JOINT REGIONAL PLANNING PANEL (Hunter and Central Coast)

Council Assessment Report

Title:	Development Application No. 42409/2012 Part 3, Proposed Section 96 (AA) - Allow the importation of Excavated Natural Material on Lot 2 DP 362339, 620 Wisemans Ferry Road, Somersby
Department:	Environment and Planning

Figure 3: Approximate Fill Volume Calculation Plan

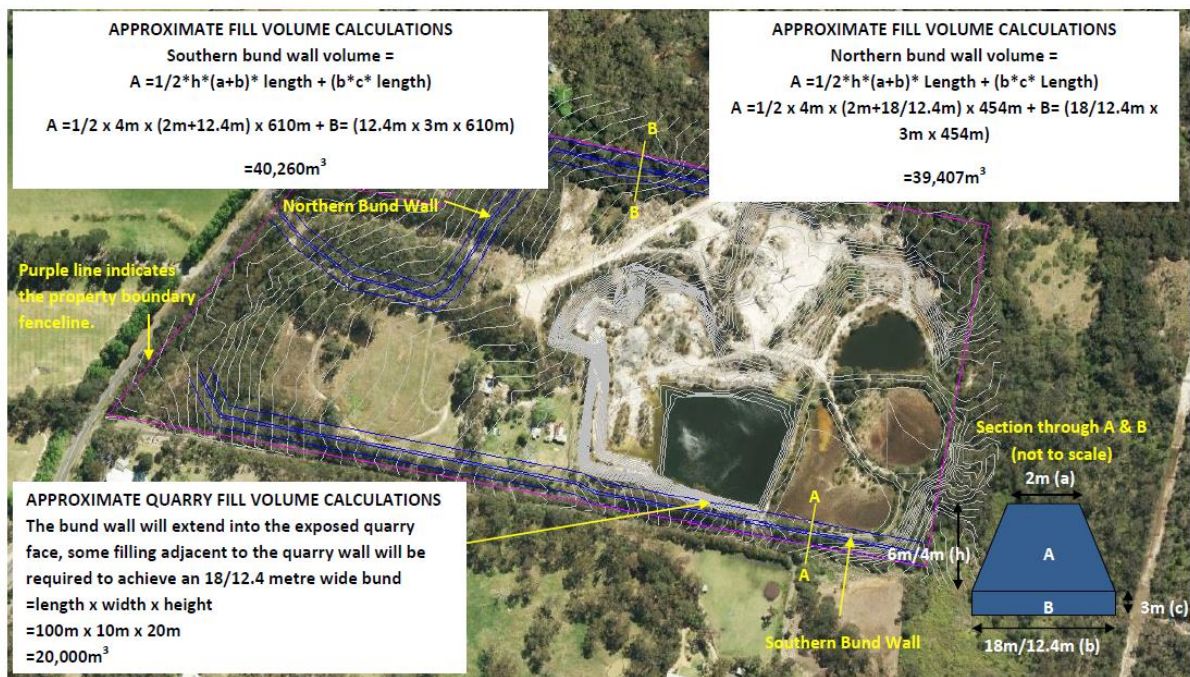
Comment: The width of the acoustic bunds as approved will remain at 12.4 metres.

At its most narrow junction, a width of approximately 7.5 metres exists between the sites southern boundary fence and the existing excavation pit.

Given the above, it would appear there is inadequate area to build the noise bund in this location and extensive filling and shoring of the adjoining excavation pit would be required. The applicant has advised that some filling to the quarry wall will be required to support the bund in this location. Refer to Figure 3.

Insufficient information has been provided with regard to the extent of fill required in this location and associated construction work.

Figure 6: Site Plan 6175 Issue D showing location of southern noise bund

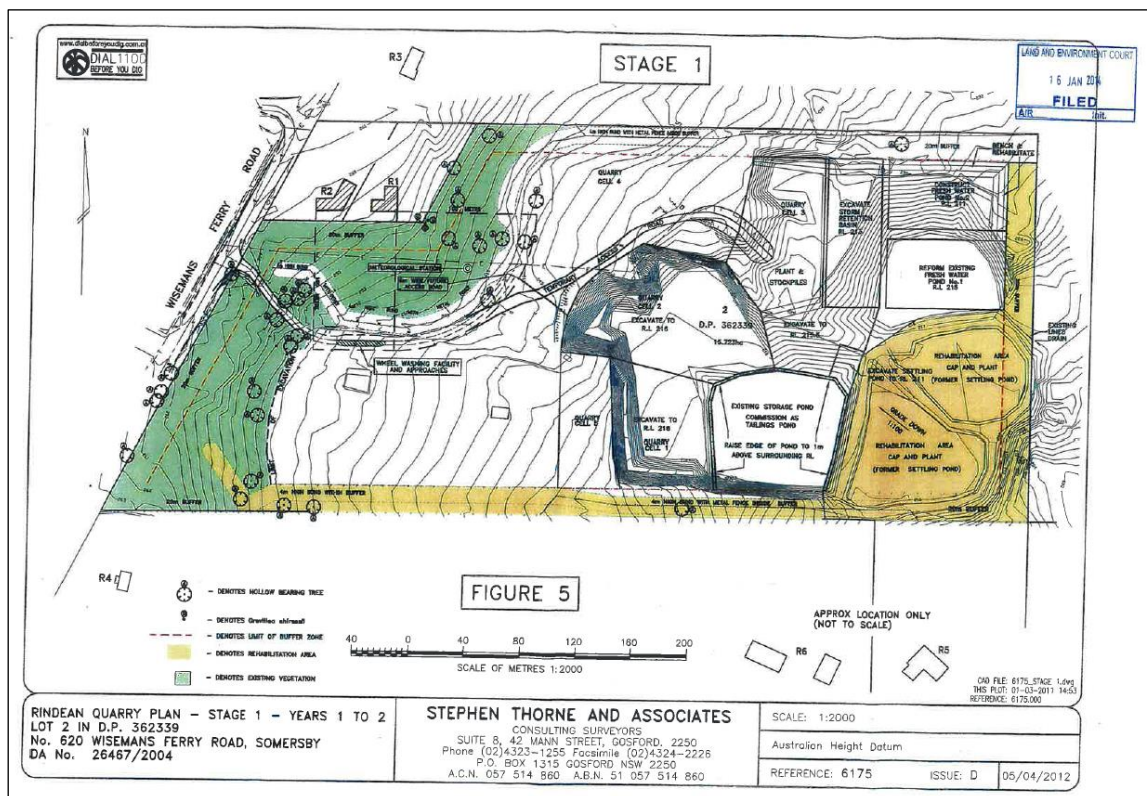
Whilst remaining unchanged, the location and size of the approved noise bunds has also been queried by the community. It is also noted that the applicants most recent fill calculation plan, provided at Figure 2 of this report, identifies acoustic bunds to a width of 12.4 and 18 metres, heights of 4 metres and 6 metres, and a peak width of 2 metres.

For clarification purposes, Consent Condition 4.3 refers to two site plans showing the location of the noise bunds and the approved Environmental Impact Statement includes a plan and design of the noise bunds. All three documents and the wording of Consent Condition 4.3 contain slightly different design/configuration of the bunds.

However, at its most narrow junction, a width of approximately 7.5 metres exists between the sites southern boundary fence and the existing excavation pit (see figure 4)

It is noted that it might be sufficient to have a lower more narrow bund in that area in order to reduce the filling of the excavation pit, however, any amendment to the size and location of the noise bund would need to be sought pursuant to a Section 96AA modification application and be supported by an accompanying acoustic assessment.

Figure 8: Design of noise bunds from EIS

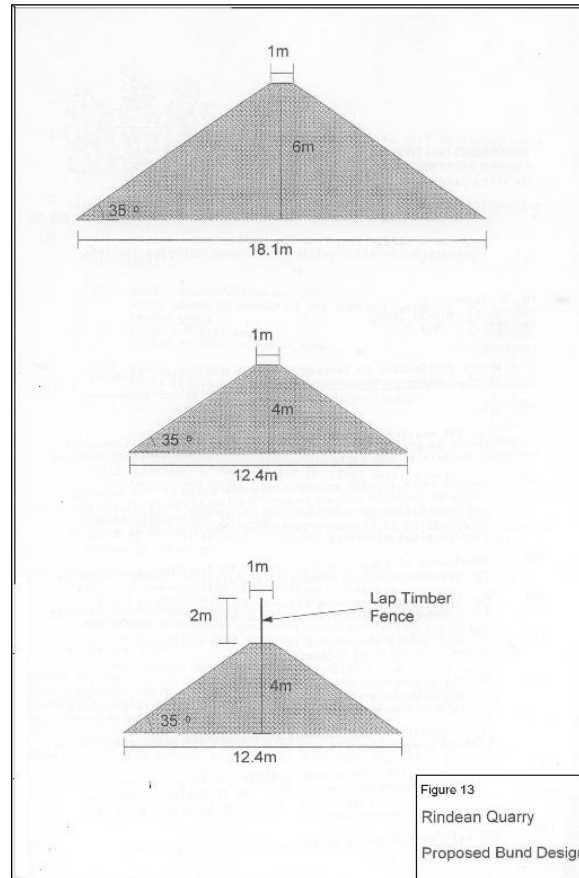
It is confirmed the court granted approval for 4 metre high, 12.4m wide bunds at the base, with a 1m wide peak and with 2m high fencing on top. The location of the approved noise bunds is as the attached court approved plans, with the exception of the south western bund which has been approved as per Figure ## of this report.

The applicant contends, the southern bund wall would require $40,260\text{m}^3$ and the northern bund wall would require $39,407\text{m}^3$. This is in addition to the $20,000\text{m}^3$ for the rehabilitation, this equates to approximately $100,000\text{m}^3$, as per the amended calculation plan. It is pertinent to note that the amount of soil required is an estimate only and will be subject to variations depending on the depth of stable substrate and compaction specifications of the material used. Notwithstanding this, no objection is raised to the importation of ENM and VENM for construction of noise bunds in accordance with the court approval.
